**CITY OF SEATTLE
ANALYSIS AND DECISION OF THE DIRECTOR OF
THE SEATTLE DEPARTMENT OF CONSTRUCTION AND INSPECTIONS**

Project Number: 3032833-LU
Applicant Name: Andy McAndrews, Terrane, Inc
Address of Proposal: 3410 23rd Ave W

Project Number: 3032834-LU
Applicant Name: Brooke Friedlander, Mirrah Homes
Address of Proposal: 3416 23rd Ave W

Subject: Response to SDCI Review Comments
3410-3420 23rd Ave W, Seattle, WA
SDCI Project # 6694812-EX

PRELIMINARY SITE PLAN
SCALE: 1" = 20'

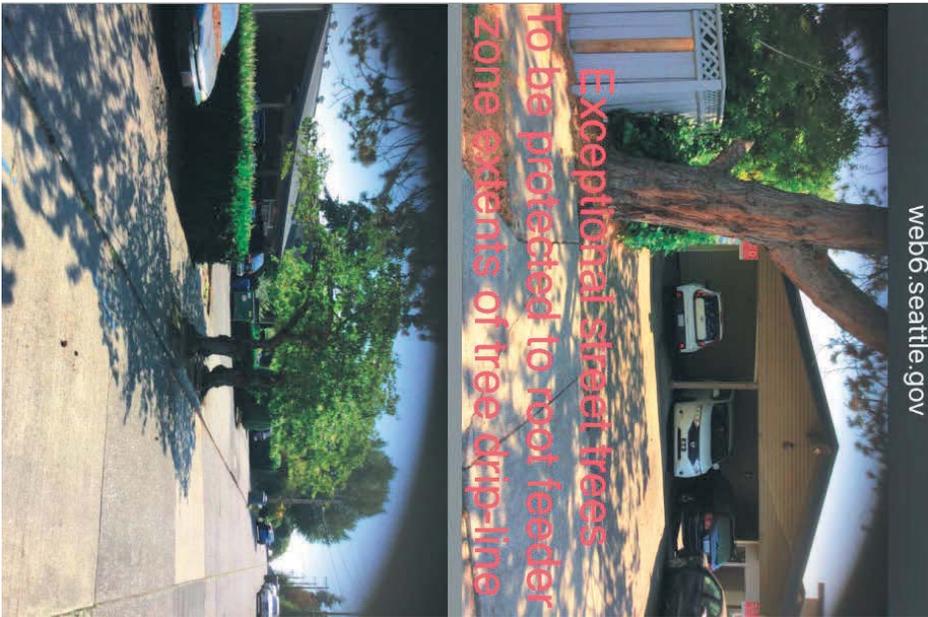
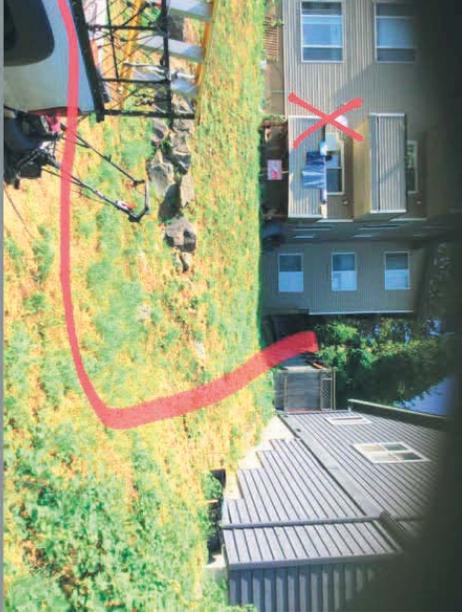
Proposal exceeds allowed by showing 1 dwelling for every 1200 sq ft

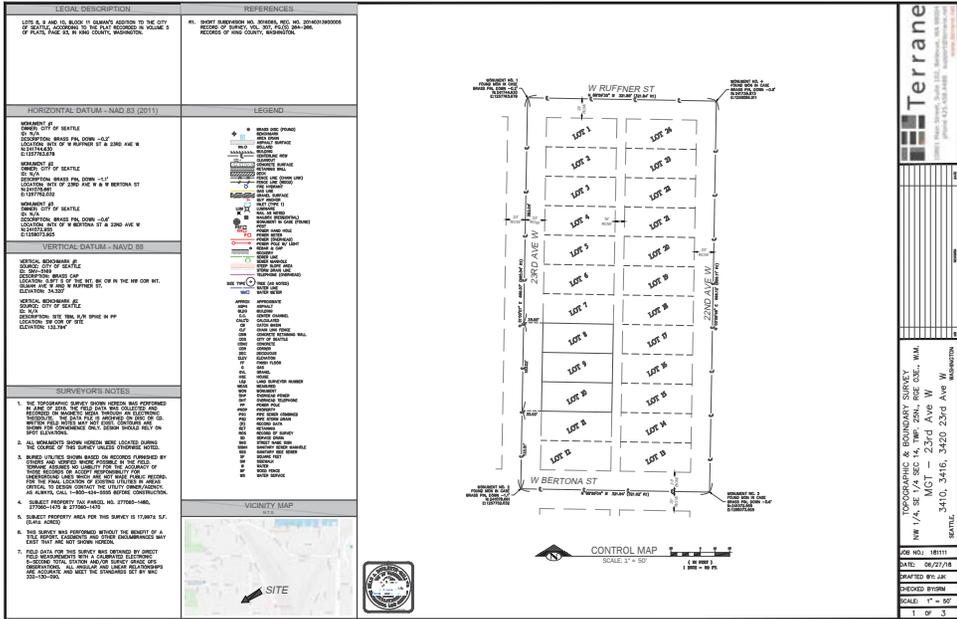
1. The Memorandum of Drainage Control (MDC) must reflect only this project. Revise the legal description, permit number and address to reflect only this project, not the project to the west.

2. The utilities for this project have been routed in a different location than the easement provided in the short subdivision.

Revise the permit number on page one and two so they include the new "CN" suffix: 6688712-CN.

Complete the "Grantor" section on page one.

Complete the "Return To" section at the top of page one.

Complete a new easement for the sanitary sewer and storm drainage or show all the sanitary and storm drainage located within the easement provided in the short subdivision.
